DESIGN CP	DRAWN BY CP	DART AEROSPACE LTD HAWKESBURY, ONTARIO, CANADA	
CHECKED J.Jh	APPROVED Jh	DRAWING NO. DSI 9250	REV. B SHEET 1 OF 1
DATE 06.11.22		TITLE BASKET CONVERSION KIT	SCALE NTS
A	03.02.17	NEW ISSUE	
B	06.11.22	ADD NAS1515H4 WASHERS, REF DSI9318

DART SERVICE INSTRUCTION

TO AMEND INSTALLATION INSTRUCTIONS D350-607 REV. F

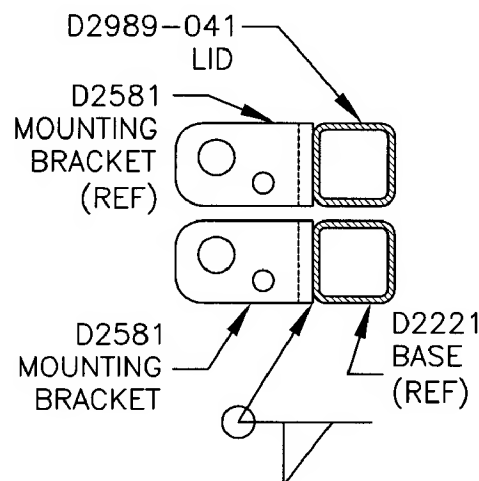
THE D350-607-041 **HELI-UTILITY-BASKET™** CAN BE CONVERTED TO A D350-607-043 AS FOLLOWS:

1. REMOVE D350-607-041 BASKET FROM THE AIRCRAFT.
2. REMOVE D2512 LID ASSEMBLY BY REMOVING QTY (2) AN4-7A BOLTS OR D2569 HINGE.
3. IF REQUIRED, WELD QTY(2) D2581 MOUNTING BRACKETS ONTO THE D2221 BASE AS SHOWN BELOW TO LINE UP WITH THE D2581 BRACKETS ON D2989-041 LID. USE ER308L FILLER ROD.
4. LOCATE D2989-043 LID ON BACK-SIDE OF D2512 LID. TRANSFER DRILL QTY (5) Ø0.257 HOLES FROM D2989-043 TO D2221 BASE. DE-BURR AND TOUCH UP WITH PAINT.
5. INSTALL D2989-043 LID USING QTY (5) AN4-22A BOLTS AND ASSOCIATED HARDWARE.
6. INSTALL D2989-041 LID ONTO D2989-043 LID USING QTY (2) AN4-13A BOLTS AND ASSOCIATED HARDWARE AS SHOWN IN SERVICE INSTRUCTION DSI9318 REV. A.
7. INSTALL D2856-400-720 ABRASION STRIPS PER ITEM 5 OF THE INSTALLATION PROCEDURE ON PAGE 4 OF D350-607 REV. F.
8. REINSTALL BASKET ON AIRCRAFT PER D350-607 REV. F AS D350-607-043.
